BULLETIN # 183

W55 & W56 WIREFEEDERS & W41-11N PCB

INCORRECT CAPACITOR C1 ON W41-11 PCB

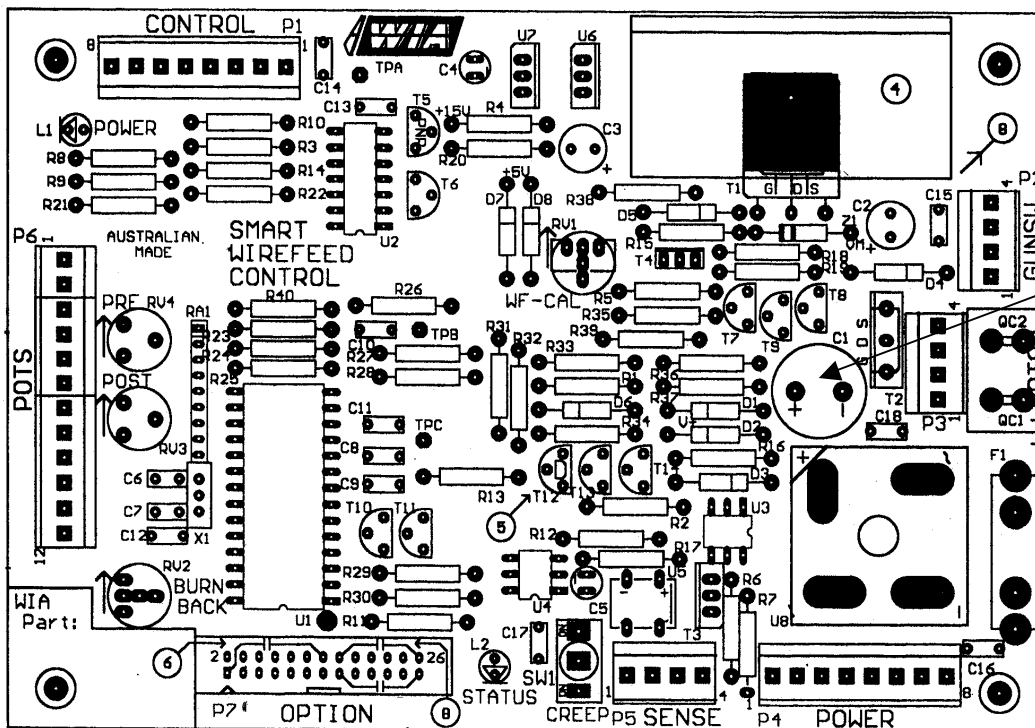
We have received a number of W41-11 Wirefeed Control pcb's with an incorrectly rated capacitor fitted. C1, the 10,000 uF electrolytic capacitor is specified at 50 volt rating, but we have received some pcb's with 35 volt capacitors fitted. After a short period of time the top of the capacitor can bulge as gassing takes place inside. The capacitor can then fail, causing an unfiltered dc voltage to pass from the bridge rectifier on the pcb. This can cause a number of different symptoms.

Read the value printed on the side of the capacitor to determine it's voltage rating. If it is not 50 volt, advise WIA Technical Support and they will arrange a replacement pcb.

In some cases a service agent may be advised to replace the capacitor in the field. If this is the case, be sure to observe correct polarity when fitting the new capacitor.
